NWBPCR Community Meeting #4 Report Out December 7, 2022

Manhattan Community Board 1 Battery Park City Committee

Provide responses to Community Board 1 to inform their resolution related to the Draft Scope of Work before the comment period for the Scoping Document ends on December 31. We will:

7: South Cove

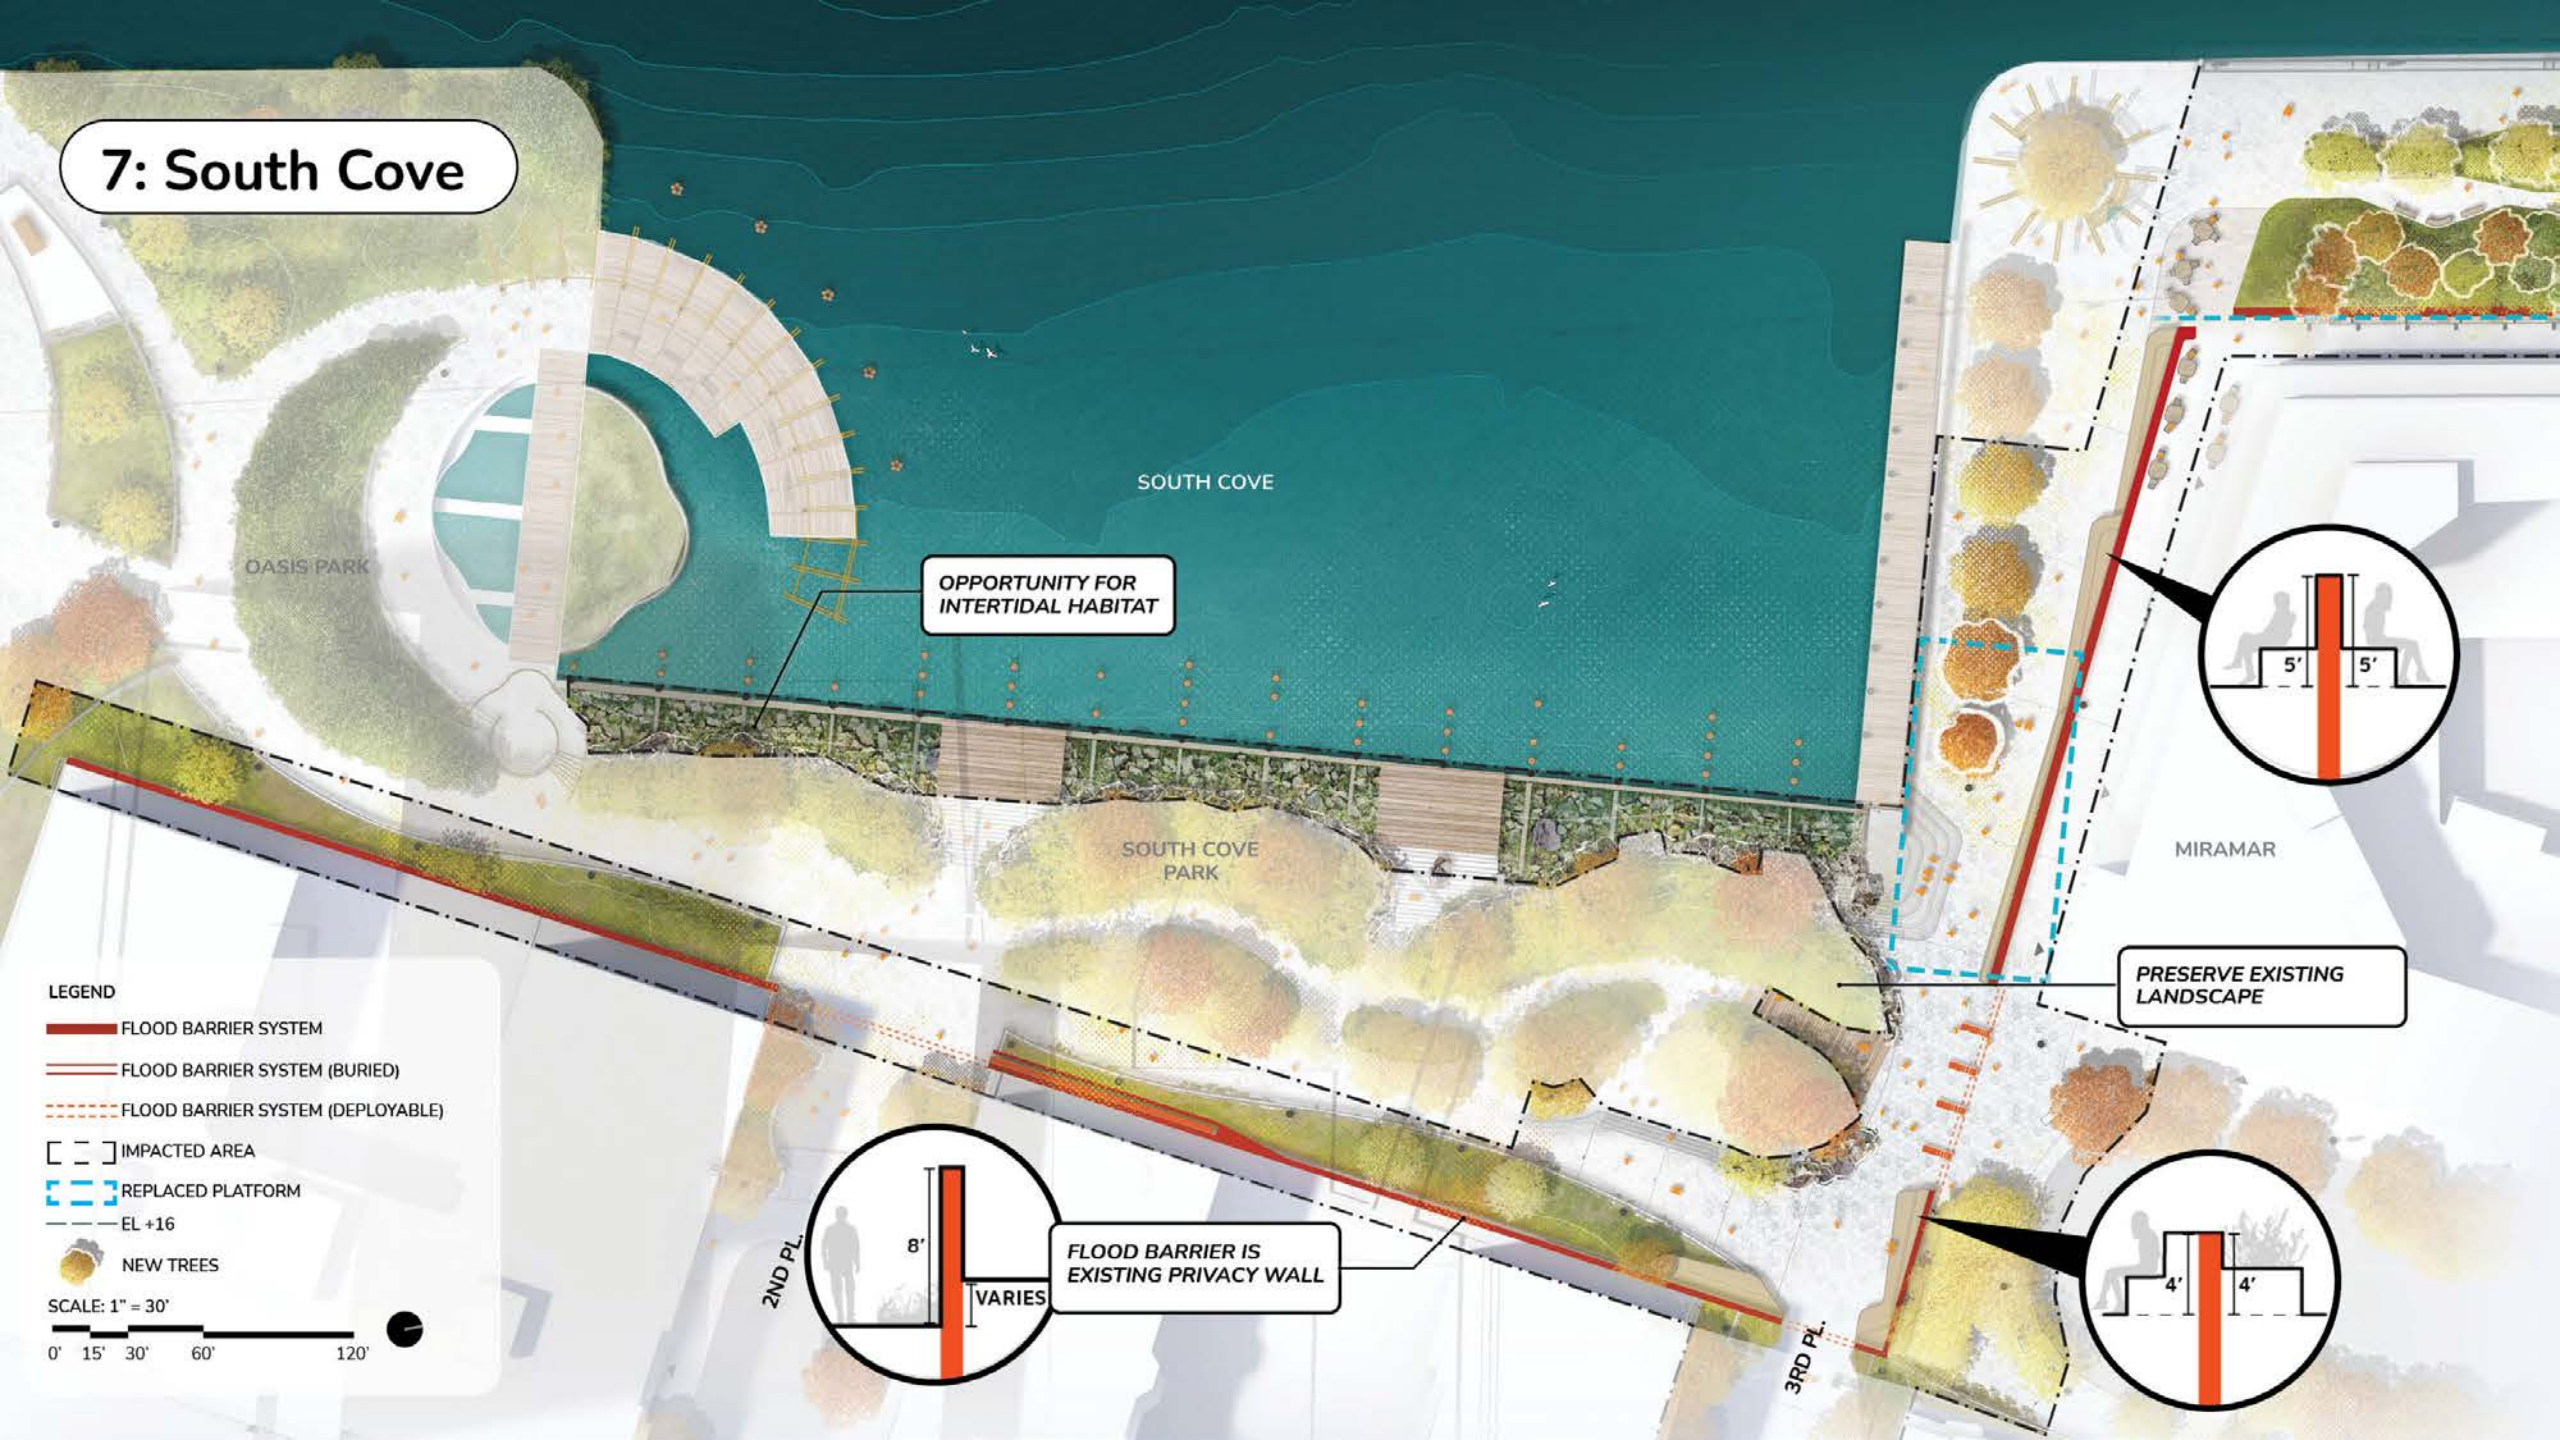
1. Are there deployables or other ways to address Regatta views?

- This seems like the best option – having walls further out (which seems like the only other option) would disrupt flow along the paths, views for people walking/biking, access, etc. Would be nice if we could transition the lower planted areas to plants that can tolerate (or even benefit from) regular inundation.

Playground

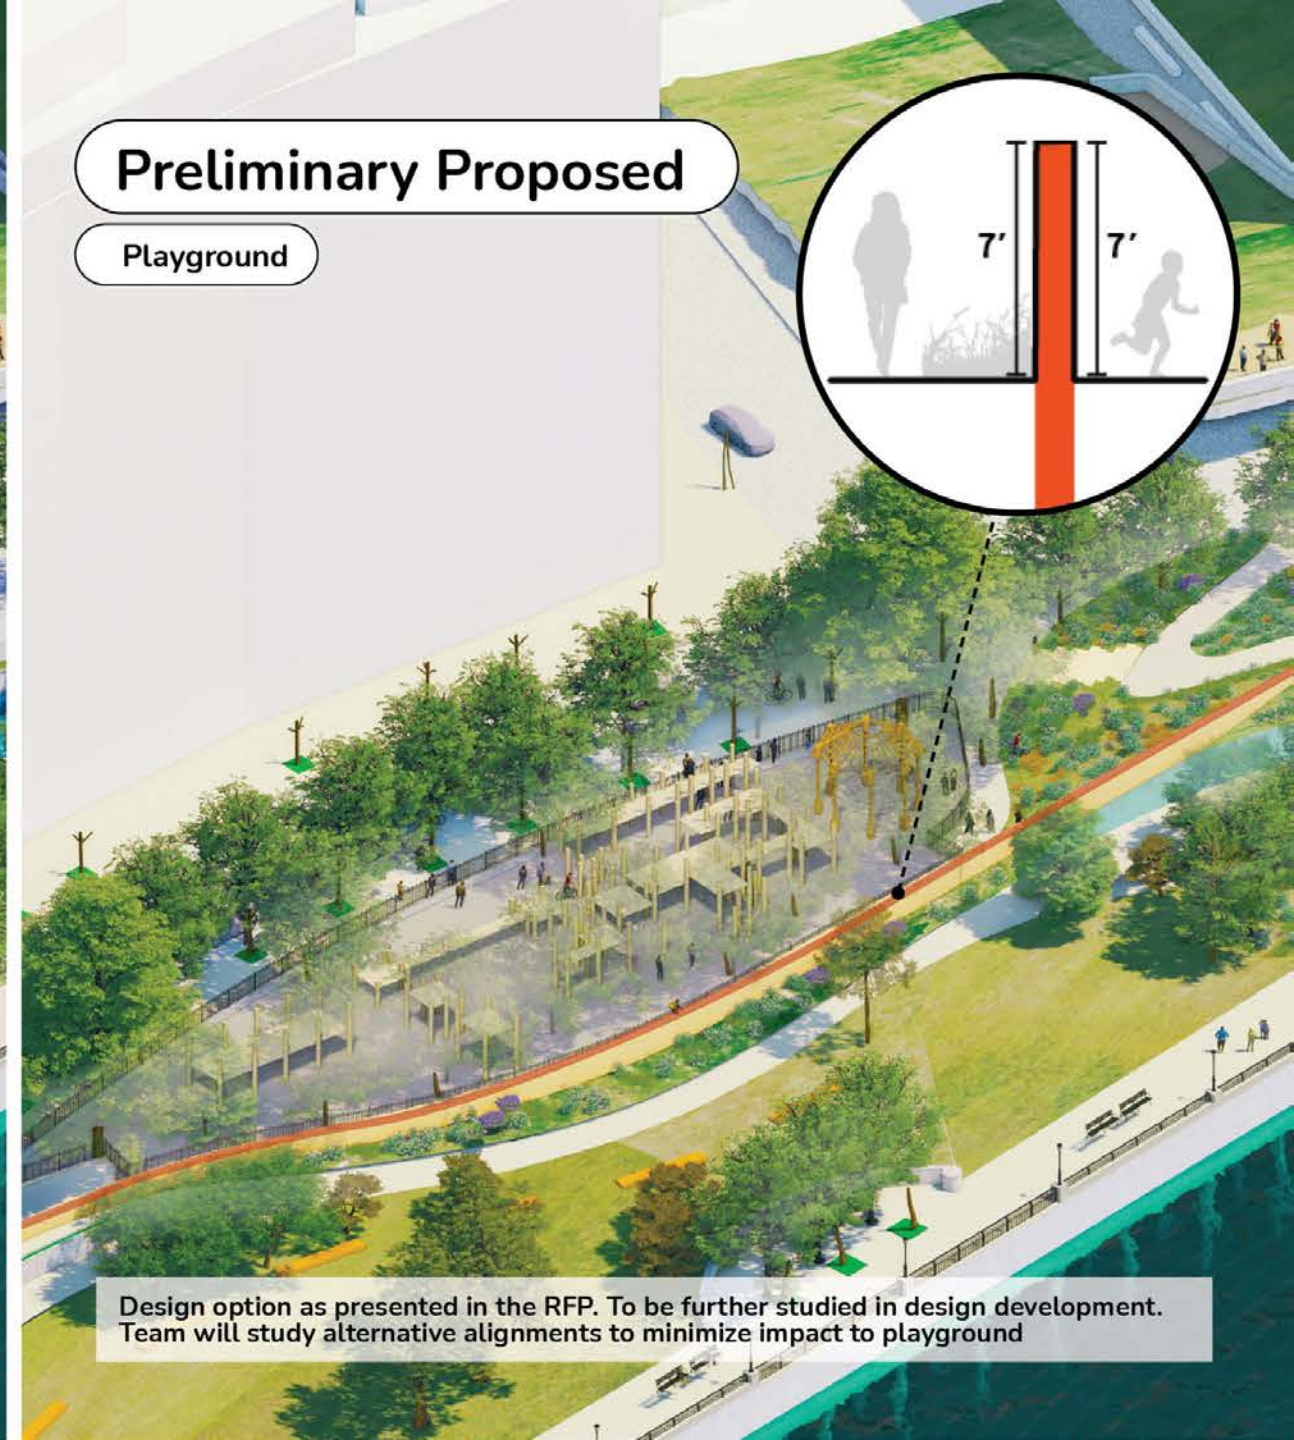
1. Why does the newly renovated playground need to be rebuilt? Couldn't the wall pass behind it?
2. Also the site says that no tree can be within 15 feet of the barrier, does that mean that trees on North End would have to be removed?
3. Are there ways to preserve the duck pond too? Would like to see options with pros/cons
4. The playground was only just reconstructed. Is there not an alignment that maintains this? What would the tradeoffs be?
5. Can the trees be relocated rather than destroying them?
6. Why can't the playground, which was recently renovated and which the community waited so long for, be kept intact and open? Why can't the plan accommodate that?
7. Can the trees to be impacted be clearly identified and details provided of what will happen to them, how the number of trees overall in the area can be maintained and what can be done to minimize loss of trees?

Design option as presented in the RFP. To be further studied in design development. Team will study alternative alignments to minimize impact to playground

REACH 4
Lily Pond
Area

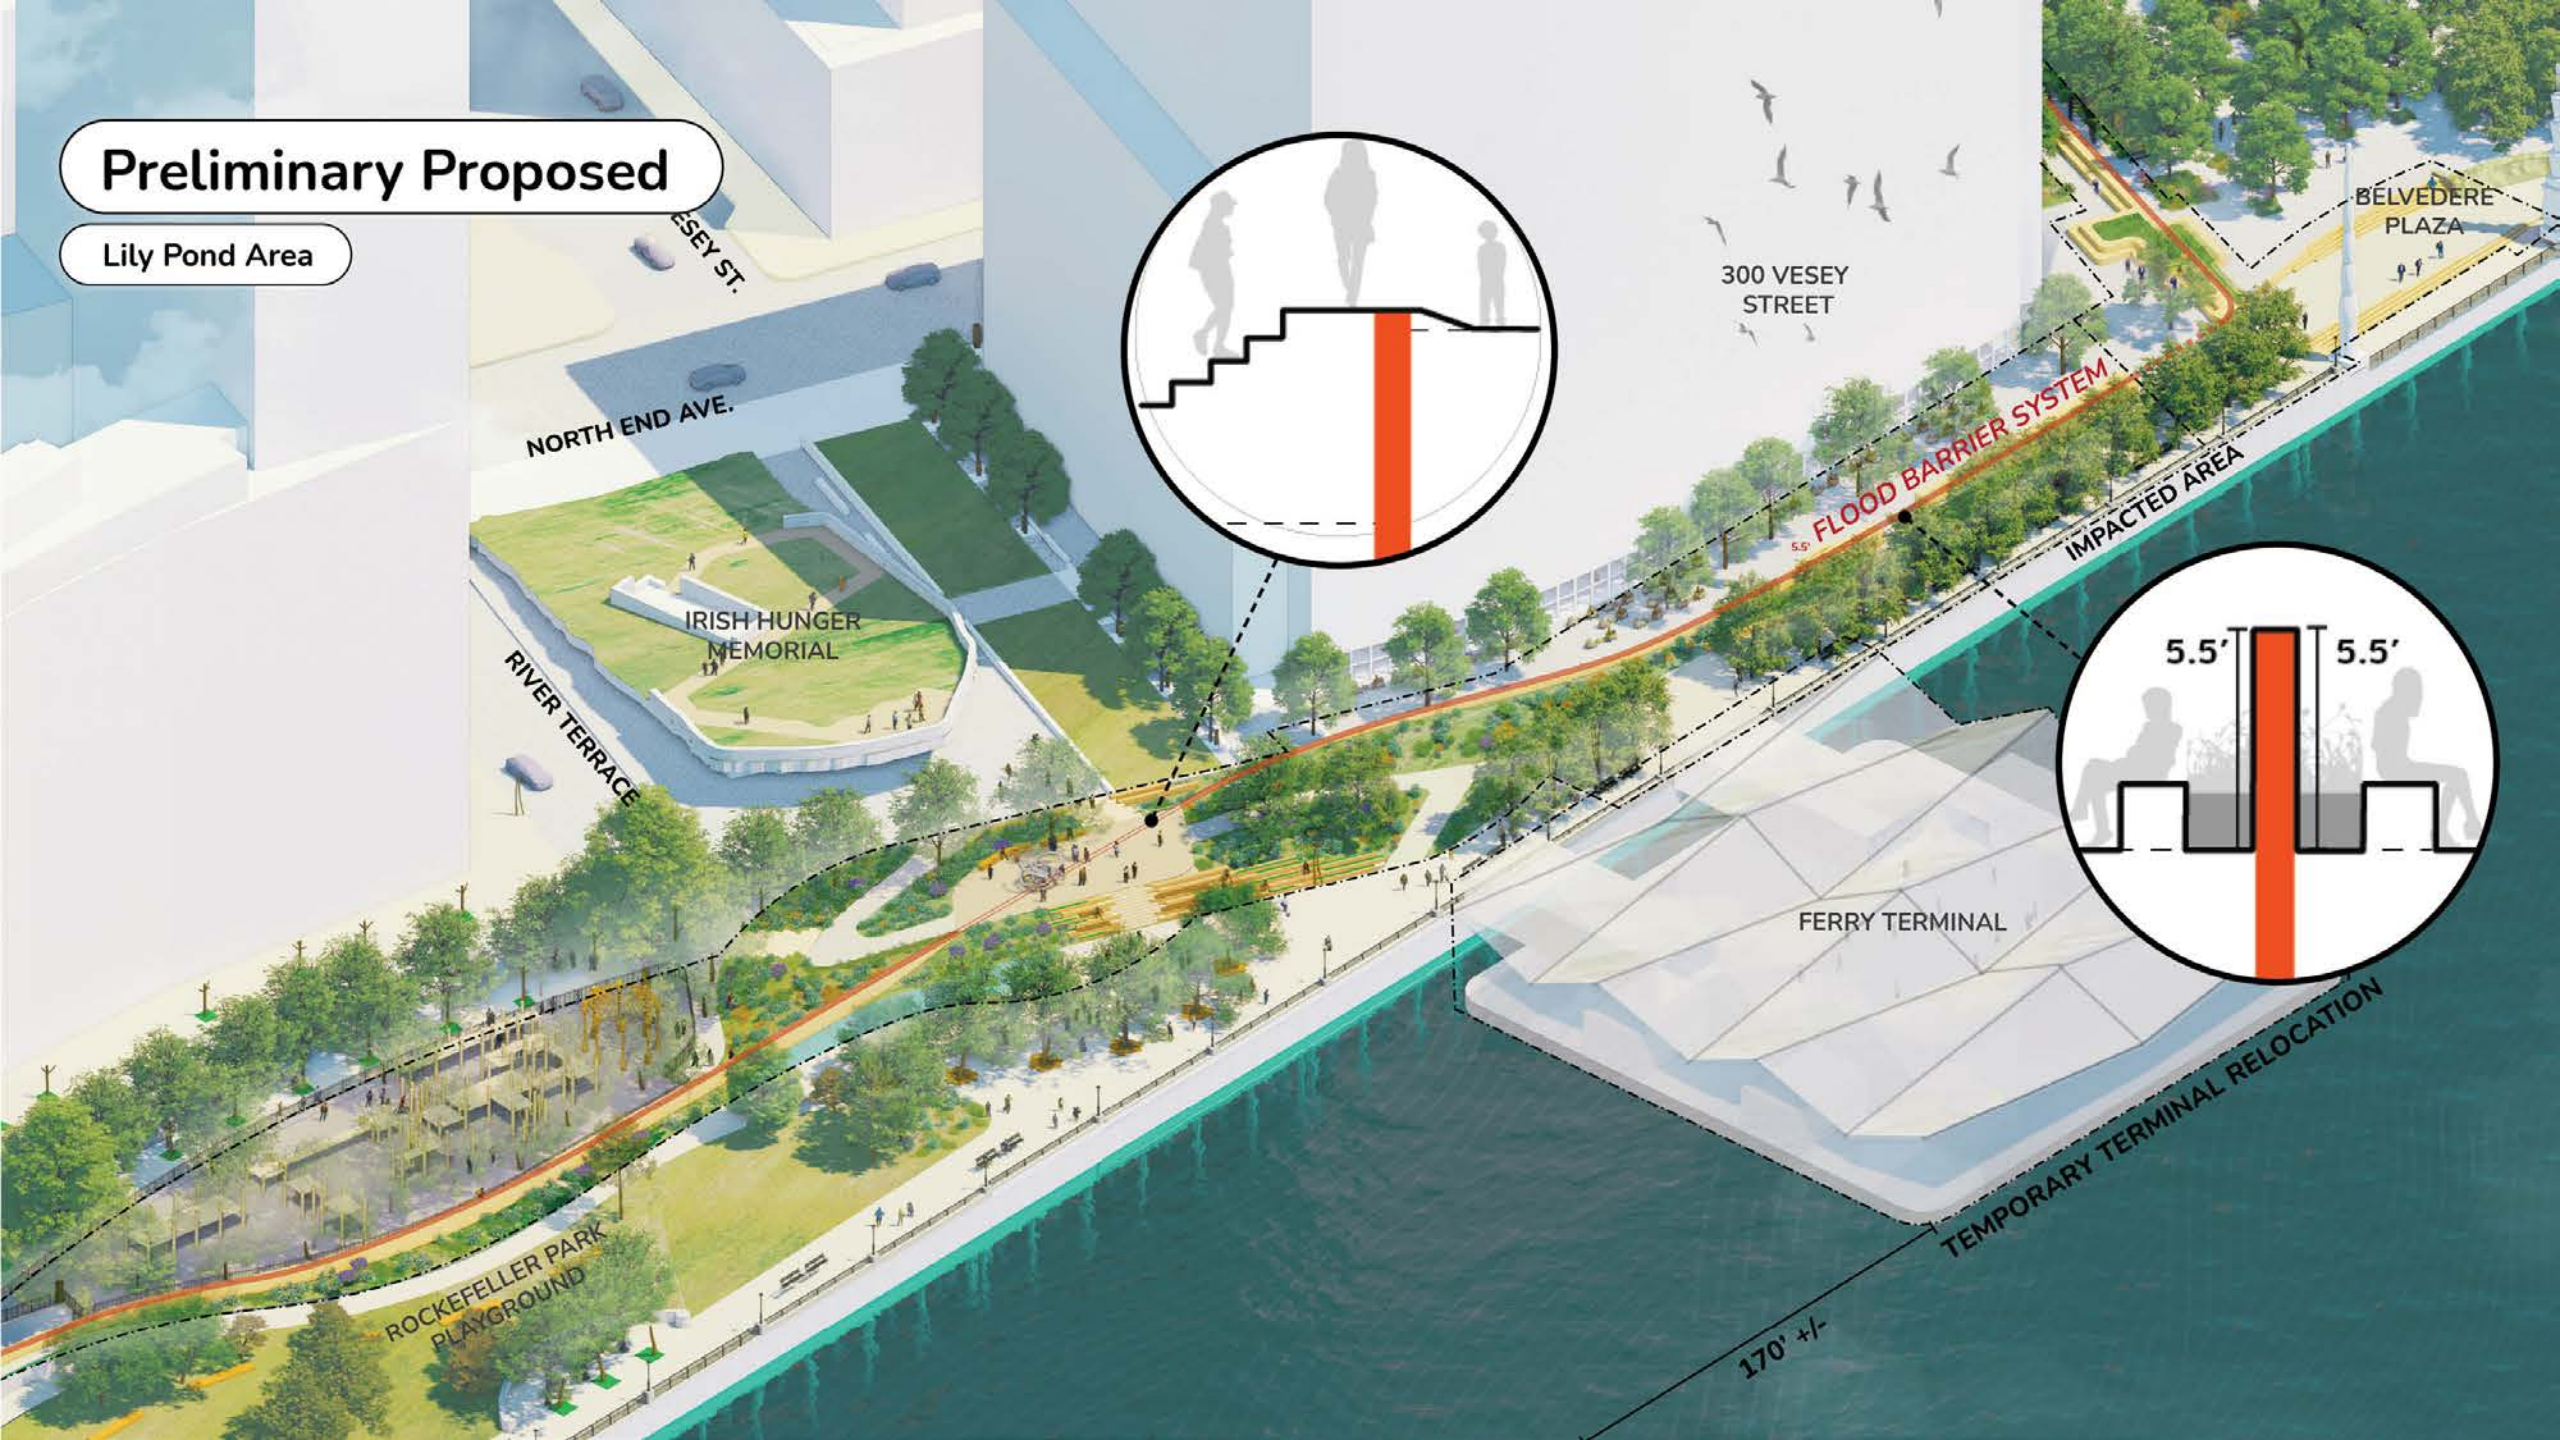
1. Could the ferry just be moved away from the shore, with longer pathways that can land passengers where there isn't construction, rather than fully relocated?.
2. Do not move the ferry terminal closer to the residential areas or the playground and do not close the playground – it was recently closed for so long. How was this potential work not considered when the decision was made to renovate the playground recently?
3. The speakers noted that a more southerly alignment of the ferry terminal (in its existing configuration) would negatively impact the comings and goings of the marina. Would an alternate configuration, one that eliminated South side docking stations at the terminal allow this?
4. How does moving the terminal improve access?

- Leave the playground alone. We endured it's closure long enough, now have lost Wagner, and you just want to keep closing essential facilities for families who live here. Please just leave the playground alone so we can play!
- Do not move the ferry terminal closer to the residential areas or the playground and do not close the playground - it was recently closed for so long.
- Adding to say that you should leave the recently renovated playground alone! You just skip over all the details on what would happen, and how long it would be closed, but we've already waited a long time for it's renovation. It should remain as is, with continuous access.

FERRY TERMINAL
RETURNS TO CURRENT
LOCATION AFTER
CONSTRUCTION
